Access Compliance Report

Public Rights-of-Way

Intersection ID: 18173	Main Street: COLONY_RD	Cross Street: PICARDY_PL	Location: NE
ADA ID: 047D83A77B76	Ramp Type: PerpDiag	Initial Pass/Fail: Fail	Overall Compliance: No
Severity Score: 13.75			
Codes/Mitigation Info/Possible Solution		Field Measurements/Component Compliance

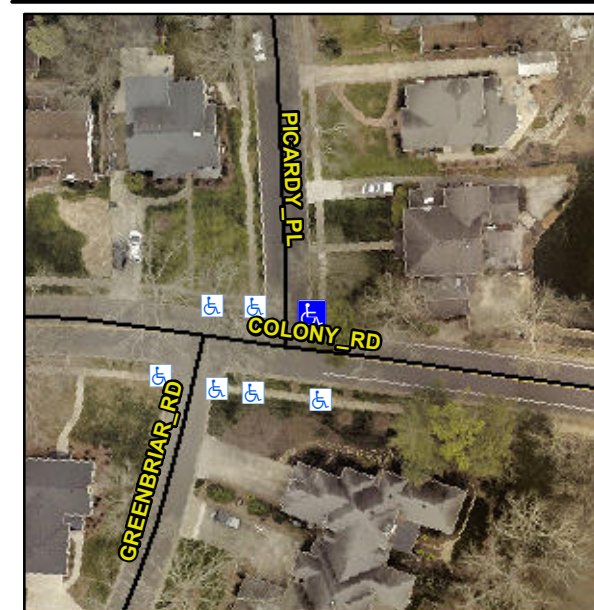
R304.2.2, R304.5.3

Compliance	Description	Data	Compliance	Description	Data
N/A	Ramp Length (in)	82.0	No	Ramp Slope (%)	9.6
Yes	Ramp Width (in)	48.0	No	Ramp XSlope (%)	4.5
N/A	Flare Type LT	N/A	N/A	Flare Type RT	N/A
N/A	Flare Slope LT (%)	N/A	N/A	Flare Slope RT (%)	N/A
N/A	Flare Traversable LT?	N/A	N/A	Flare Traversable RT?	N/A
N/A	Landing Length (in)	N/A	N/A	DWS Provided?	N/A
N/A	Landing Width (in)	N/A	N/A	DWS Contrast?	N/A
N/A	Landing Slope (%)	N/A	N/A	DWS Length (in)	N/A
N/A	Landing X Slope (%)	N/A	N/A	DWS Full Width?	N/A
N/A	Landing Curb? (Y/N)	N/A	N/A	DWS Offset (in)	N/A
N/A	Shared Landing?	N/A			
N/A	Gutter Ponding?	N/A	N/A	Gutter Slope (%)	N/A
N/A	Gutter Lip Ht (in)	N/A	N/A	Gutter X Slope (%)	N/A
N/A	Painted X Walk1?	No	N/A	Painted X Walk2?	No
	X Walk 1 Direction	To NW		X Walk 2 Direction	To S
N/A	X Walk 1 Width (in)	N/A	N/A	X Walk 2 Width (in)	N/A
	X Walk 1 Slope (%)	5.3		X Walk 2 Slope (%)	3.3
	X Walk 1 X Slope (%)	2.0		X Walk 2 X Slope (%)	4.1

Remove & Replace Curb Ramp With Two New Directional Ramps or Equivalent.
